TB 117A

TECHNICAL BULLETIN

Product : Maxilift MRLi Hydraulic Passenger Lift

Subject : Introduction of NGV A3 Electronic Valve (REVISION A)

'NGV A3' valve

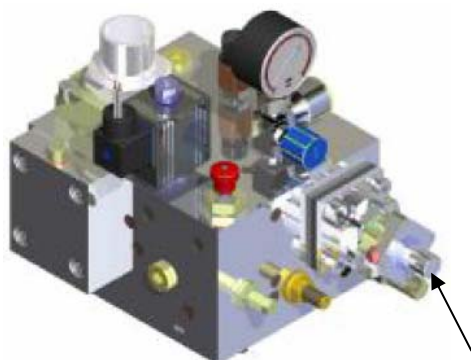
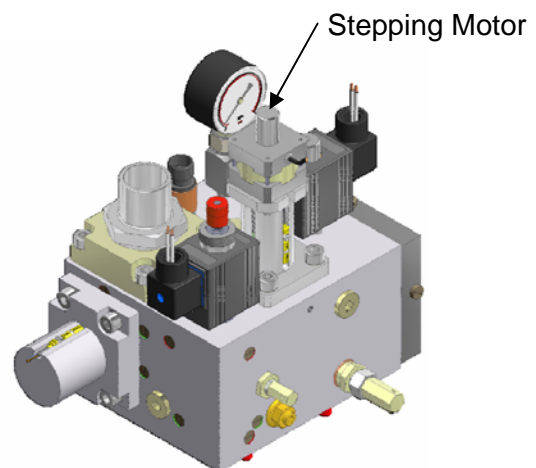
From October 2011 the 'current NGV' valve fitted to Maxilift MRLi models will be phased out by GMV and replaced by its successor known as the 'NGV A3'.

'NGV A3' is GMV's latest electronic valve - it is certified to meet the new safety requirements of EN81-2 Amendment A3, namely the prevention of unintended movement.

The physical size and shape of the MRL tank remains the same. The purpose of this bulletin is to give you an awareness of the changes.

Pawl device - the pawl device is not required on the ‘NGV A3’ as the valve block incorporates two normally closed valves with three sensors to monitor correct operation at all times.
